#### PROPOSED AMENDMENTS TO THE SUBSTANTIVE SITE PLAN APPROVAL

# Nova Centre Schematic Design Submission

Halifax, Nova Scotia

NORTH ELEVATION

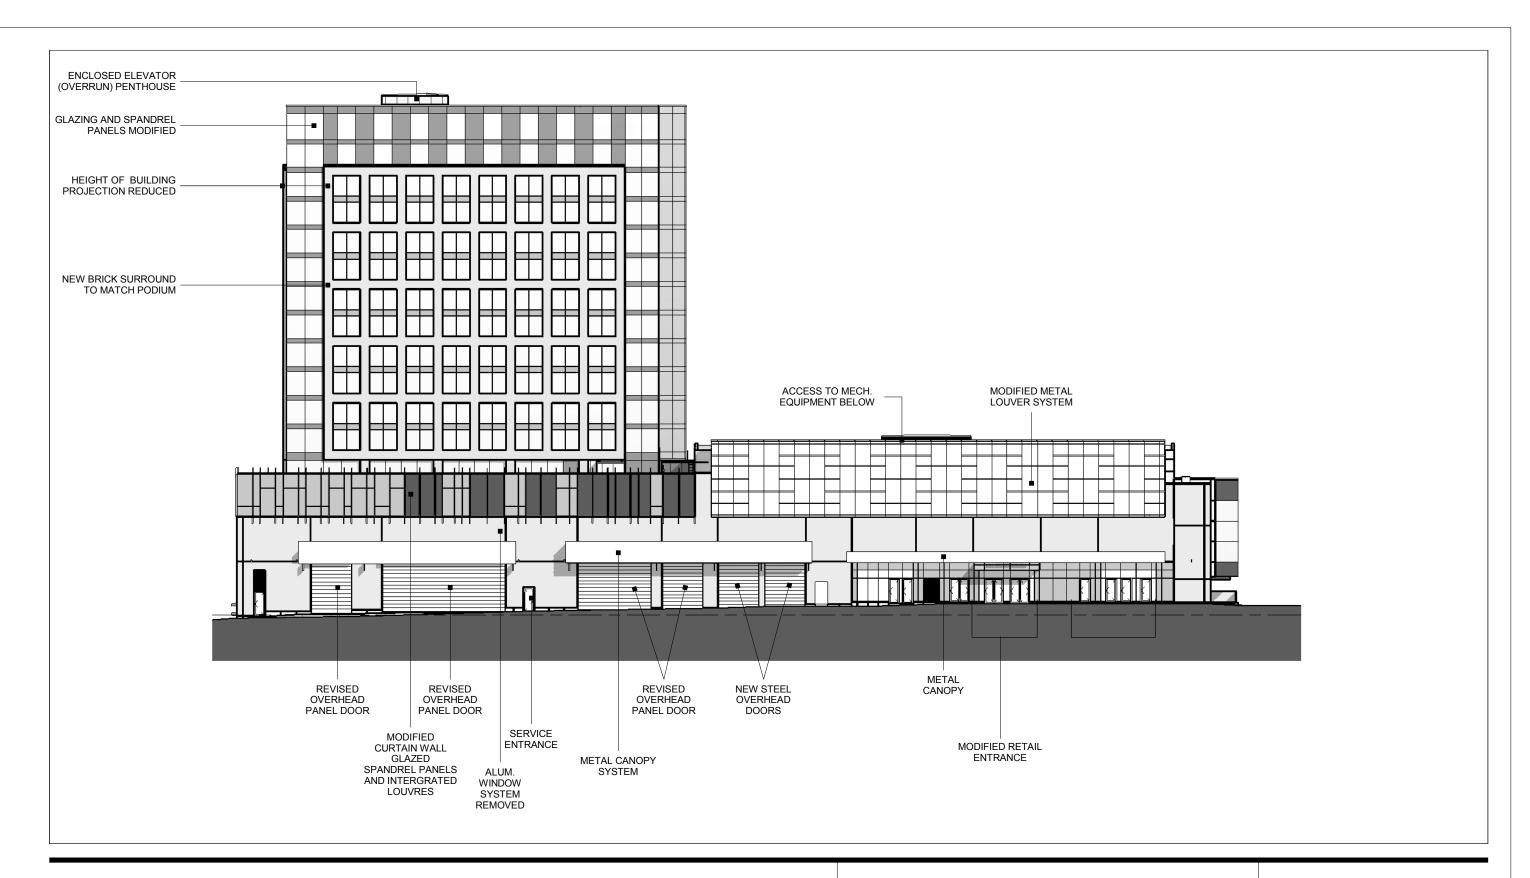
- 1. Addition of brick surrounds at the north and west elevations of the hotel tower. The intention here is twofold. To distinguish the hotel tower from the office towers and to recall the heritage of Halifax through the use of `punched` windows and masonry.

- 2. The corner detail at the southwest and northeast corners of the hotel tower has been modified. Achieves a better integration of the tower's square and curved geometry.

- 7. Delete decorative `punched` windows from north and west elevations. This modification was made at the request of the hotel operator who intends to use the north elevation area for signage. The west elevation was modified for consistency.

- 13. The curtain wall at Grafton Plaza, north elevation, has been modified.
- 14. Curtain wall at the north and west elevations of the hotel podium has been modified to accommodate additional louvers. This modification responds to a change in the convention centre program which increased the anticipated air handling demand.
